**ADDENDUM NO. 2**

PROJECT TITLE:  
**REPLACEMENT OF  
BRIDGE NO. 06896, ROUTE 156  
OVER ARMSTRONG BROOK**

TOWN:  
**OLD LYME**  
DRAWING TITLE:  
**SIGN AND PAVEMENT  
MARKING PLAN**

PROJECT NO.  
**104-175**  
DRAWING NO.  
**SPM-01**  
SHEET NO.  
**05.02.A2**

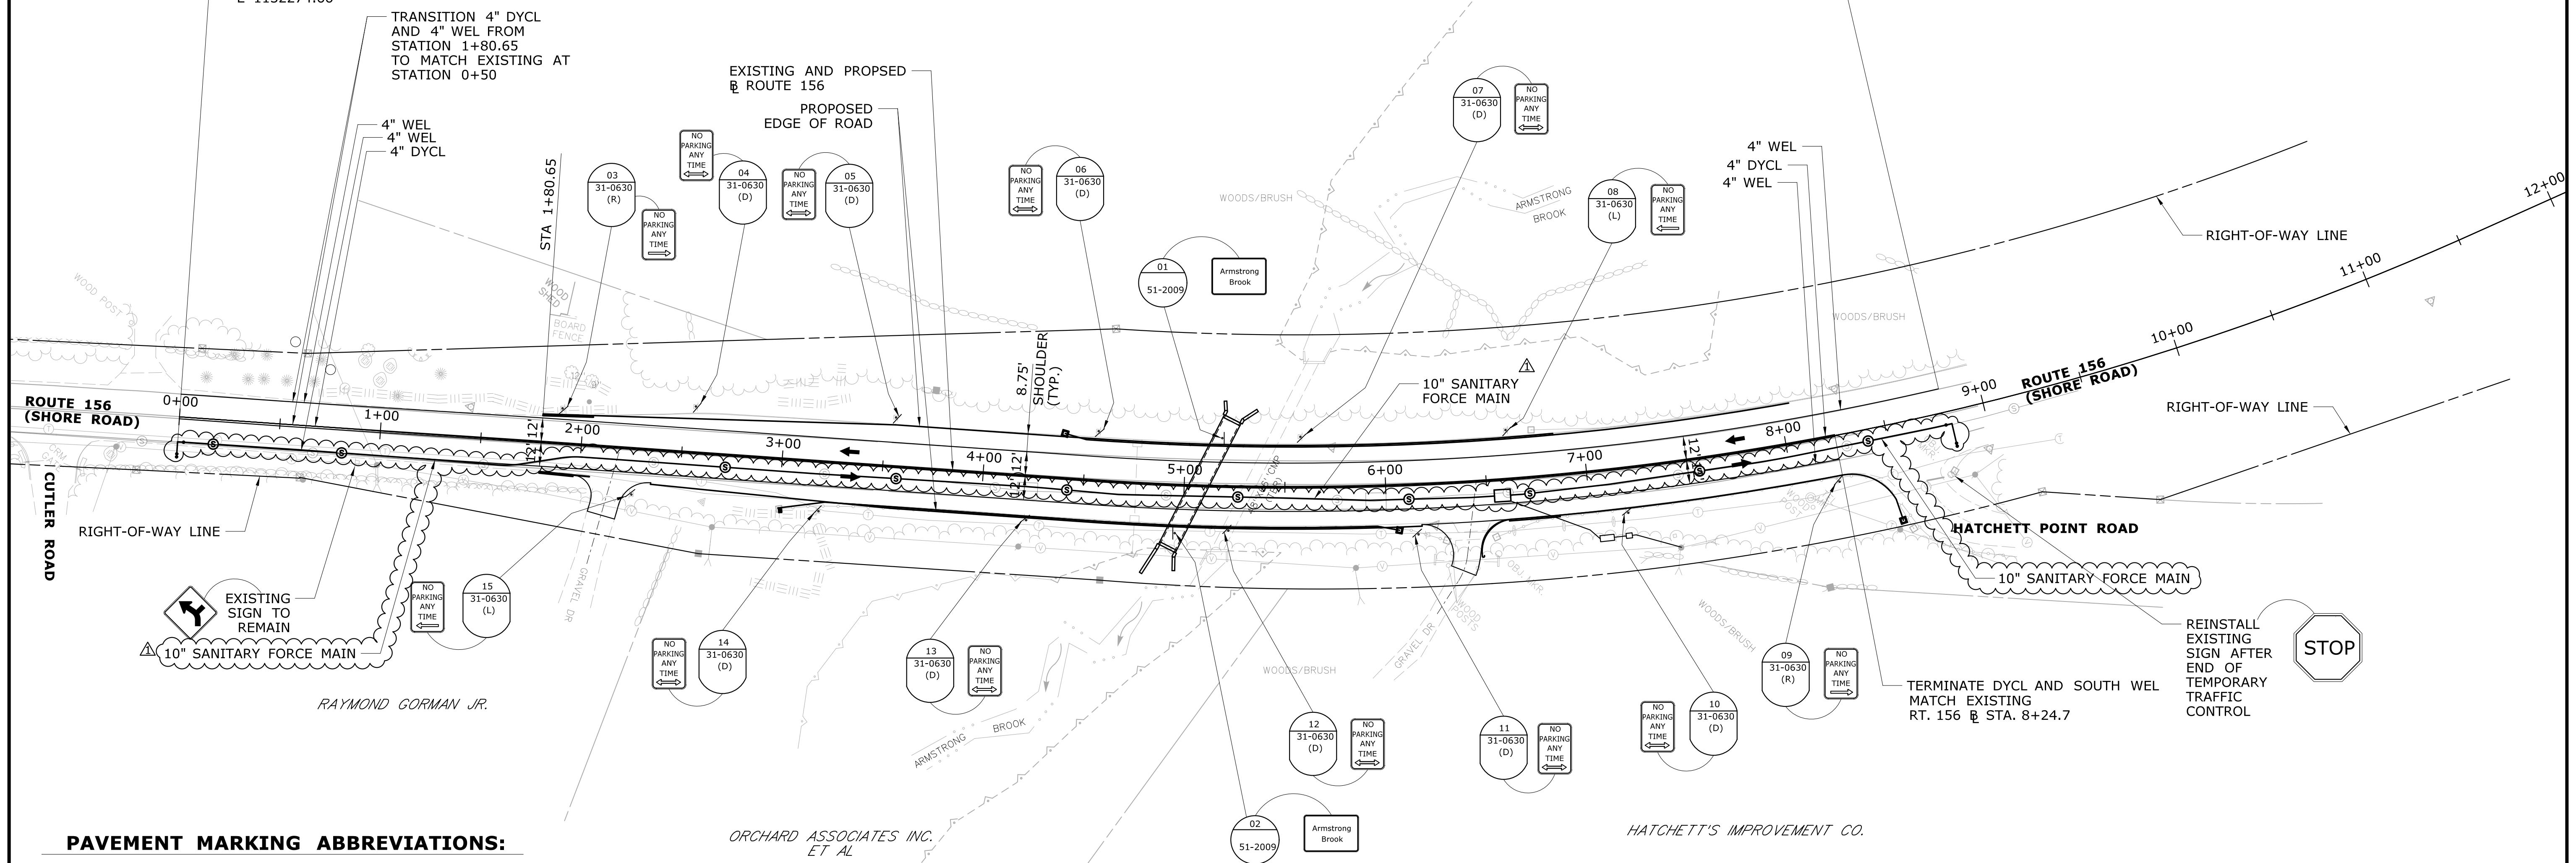
REV.	DATE	REVISION DESCRIPTION	SHEET NO.
1	1.31.25	ADD SANITARY FORCE MAIN	05.02

PROJECT NO. 104-175  
DRAWING NO. TCP-01  
SHEET NO. 05.03.A2

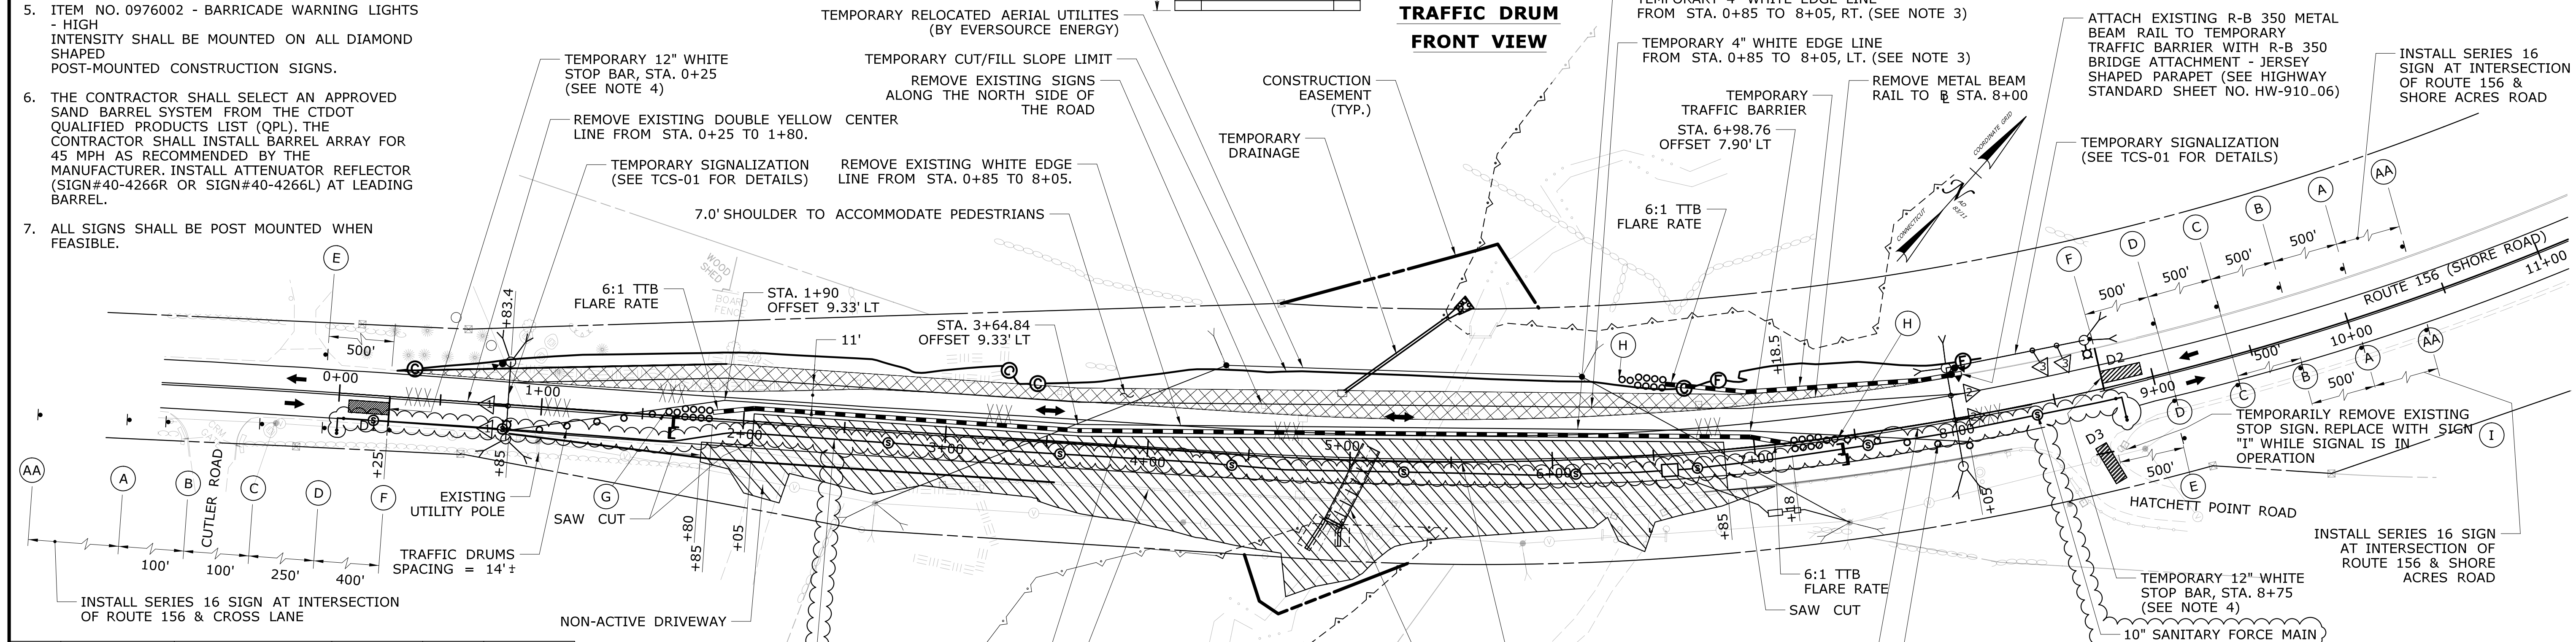
REV. DATE: 1.31.25  
REVISION DESCRIPTION: ADD SANITARY FORCE MAIN  
SHEET NO.: 05.03

PROJECT NO.  
**104-175**  
DRAWING NO.  
**TCP-02**  
SHEET NO.  
**05.04.A2**

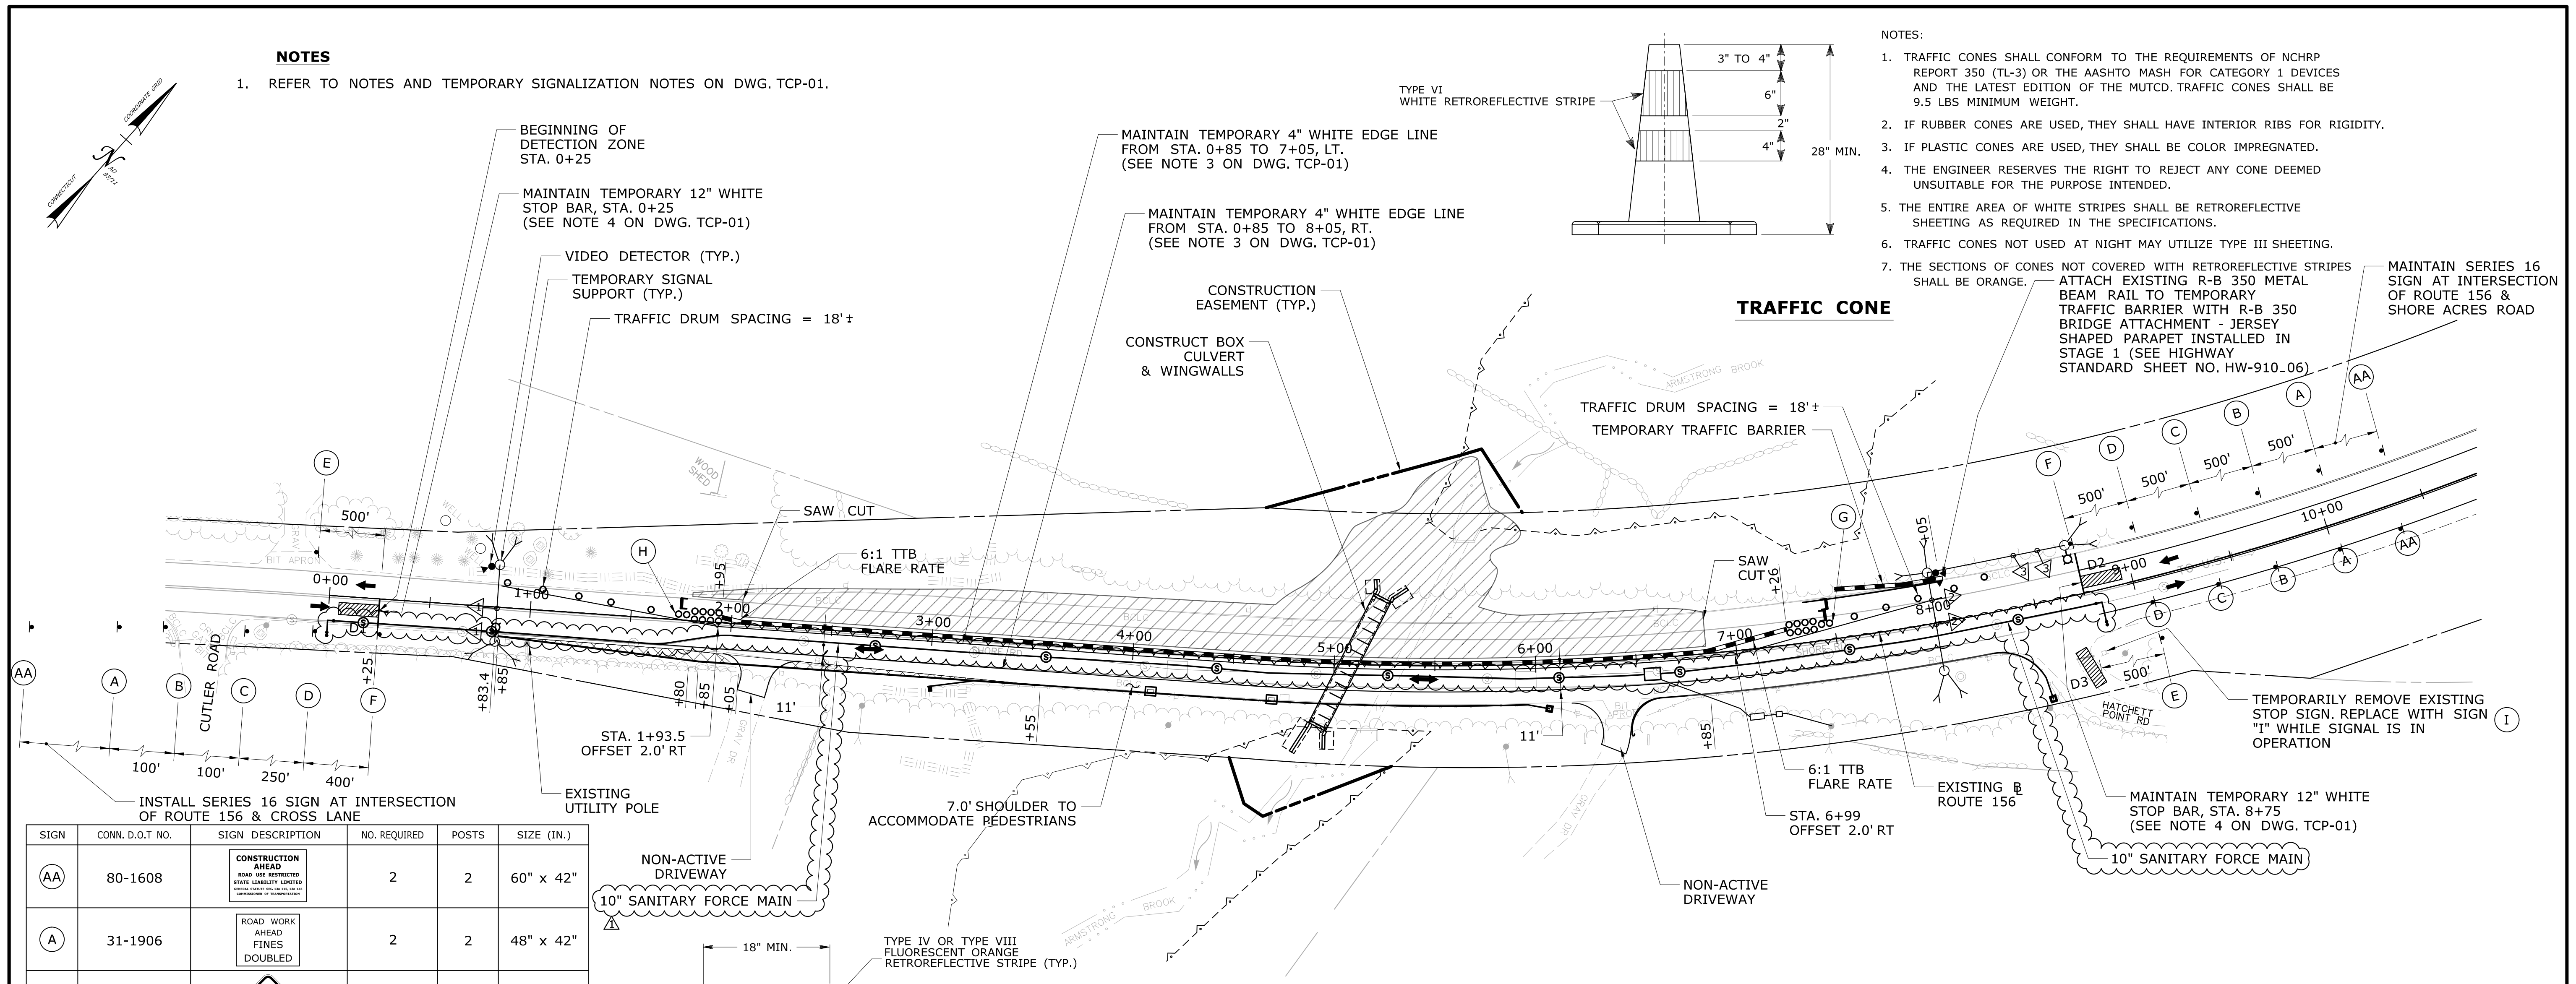
REV.	DATE	REVISION DESCRIPTION	SHEET NO.
1	1.31.25	ADD SANITARY FORCE MAIN	05.04

DRAWING TITLE:	DRAWING NO.
<b>TEMPORARY TRAFFIC CONTROL SIGNAL PLAN</b>	TCS-01

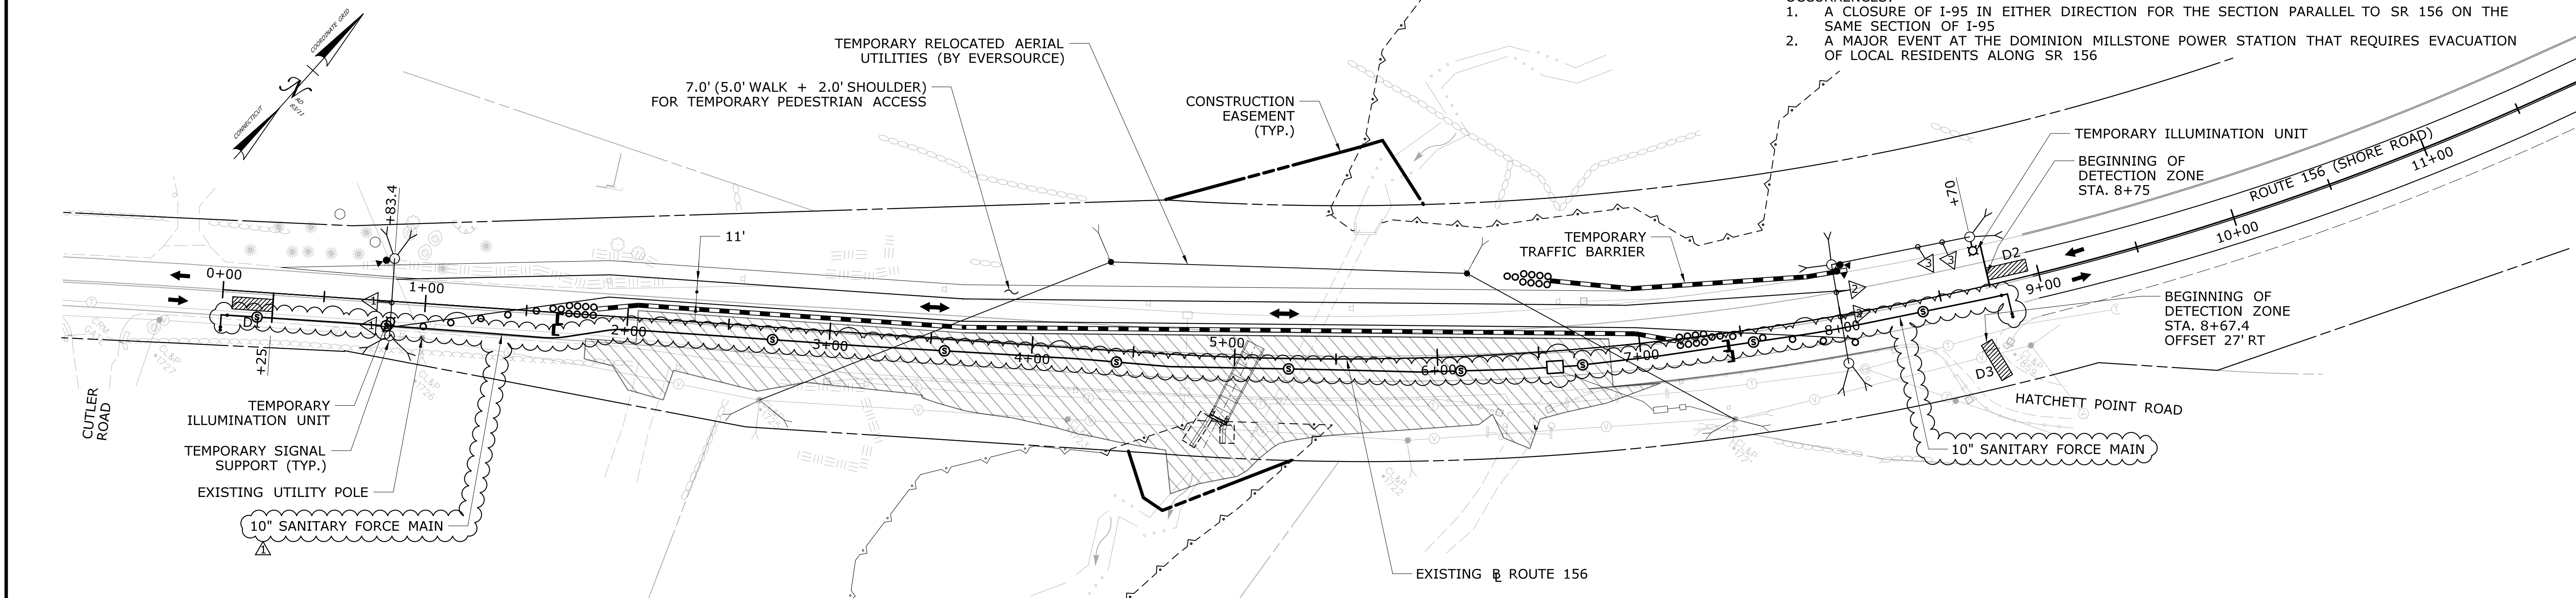
NO.	DATE	REVISION DESCRIPTION
1	1.31.25	ADD SANITARY FORCE MAIN
